ADDITION & ALTERATIONS to the SOULE RESIDENCE

SITE INSPECTION SHEET

RE: Well Variance Request

PLOT PLAN scale 1"=30'-0"

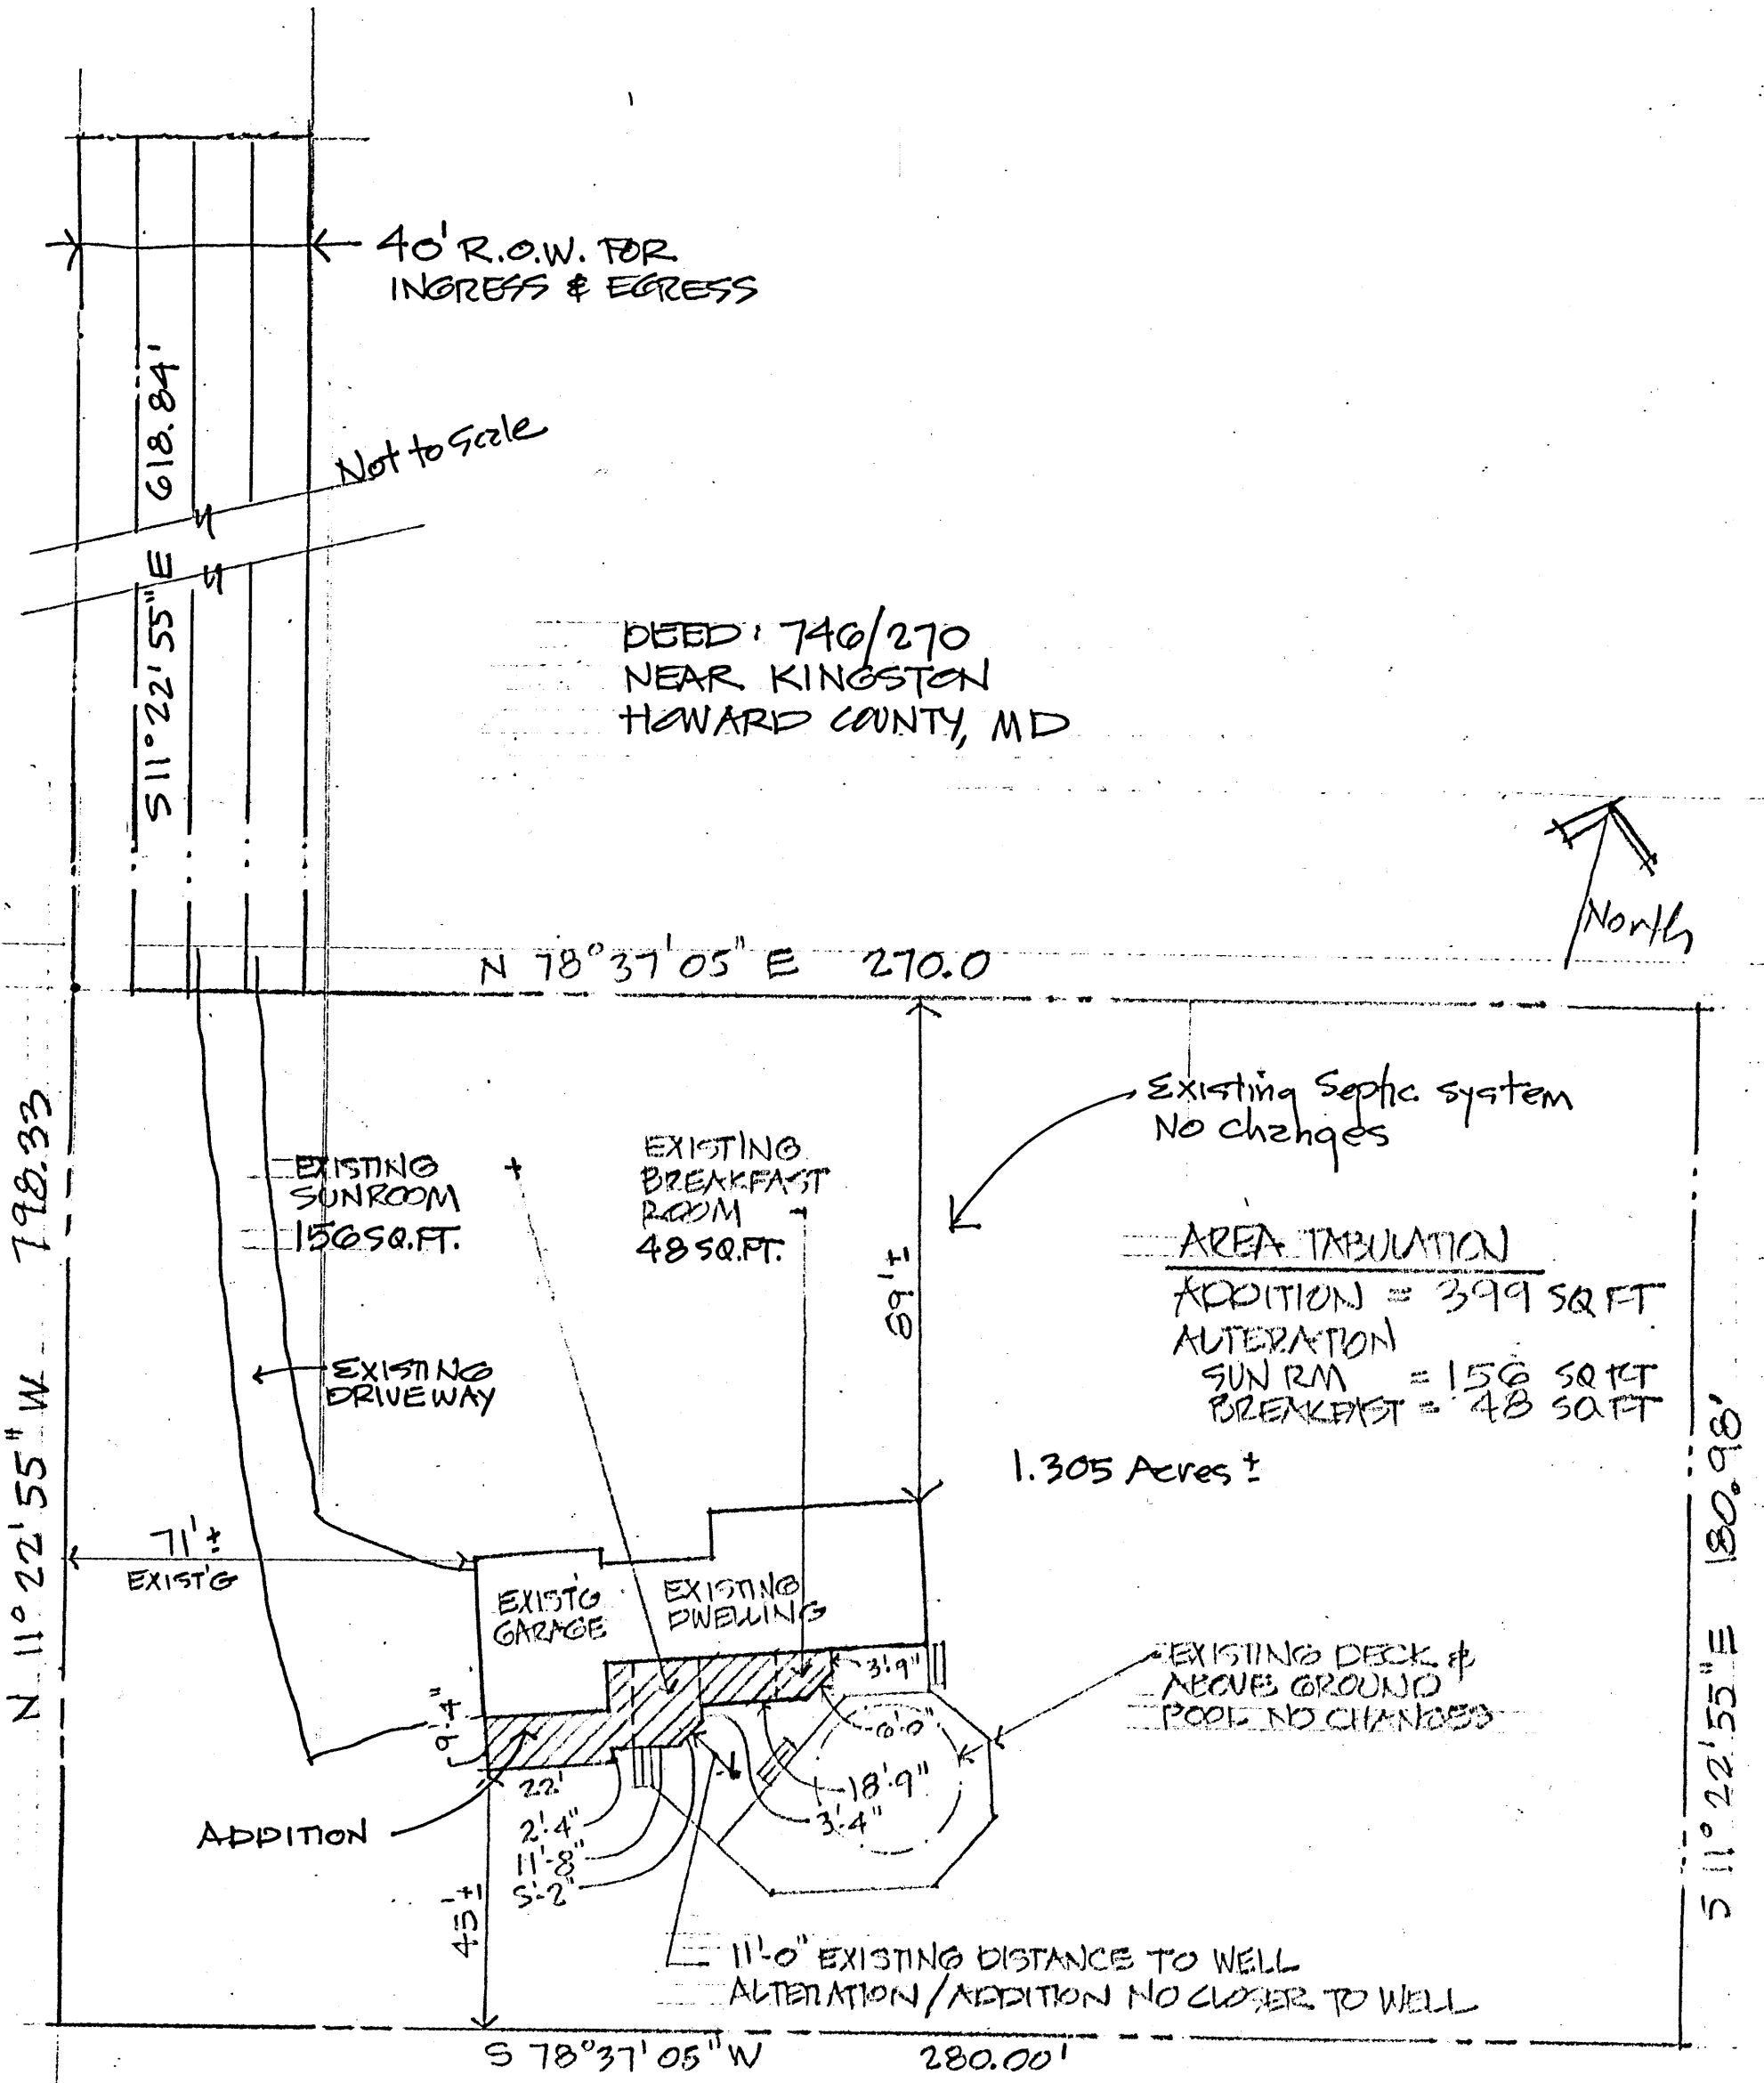
COMMENTS: existing Deck & Pool built w/o Permit by
previous owner / New construction will not encroach
any further than what currently exists / have softeners

We have received a variance requesting the required 30' setback to a foundation for a well at the above referenced property be waived to 11'. This agency will grant your approval for the variance at the property as this condition already exists. Furthermore, since the usual allowable request is 20', prior to approval of the building permit, termite or wood boring proof construction methods will need to be placed at the connection point of the structure to the foundation.
